IREDELL COUNTY HEALTH DEPARTMENT

IMPROVEMENT PERMIT / AUTHORIZATION TO CONSTRUCT / OPERATION PERMIT / EXISTING SYSTEM INSPECTIO

PERMIT# 118352 PIN# 4628963699 Cell 564-8806 DATE 2-20-04

SUBDIVISION Point of View BLOCK / SECTION ____ LOT 15 LOT AREA 1.2 Acre SITE CLASS PS DESIGN FLOW 360gpd L.T.A.R. .3 Area

INITIAL SITE SKETCH

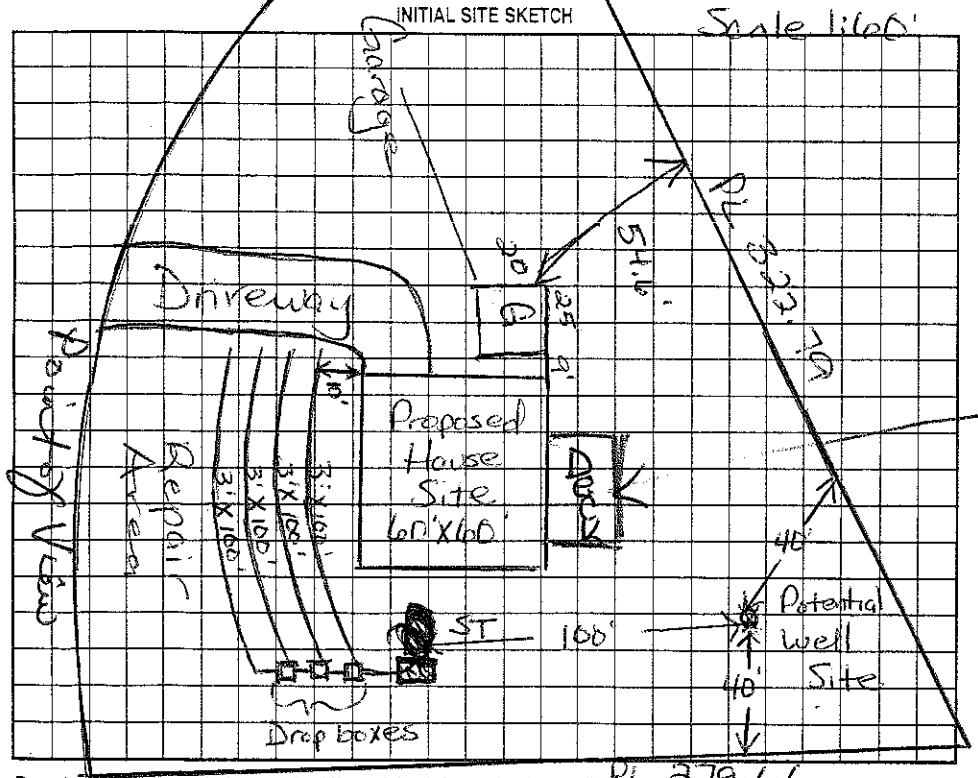
Comments:/Conditions: Keep Septic System 10' From PL

Note: Neighbor's Well on lot 16 is 40' From PL

Location of the proposed 18'X34' Deck addition does not appear to impact the existing on-site septic system.**NOTE: Must keep at least 25ft from well

The proposed / existing Garage addition does not appear to impact the existing septic system

**NOTE: Garage must be at least 25 from well
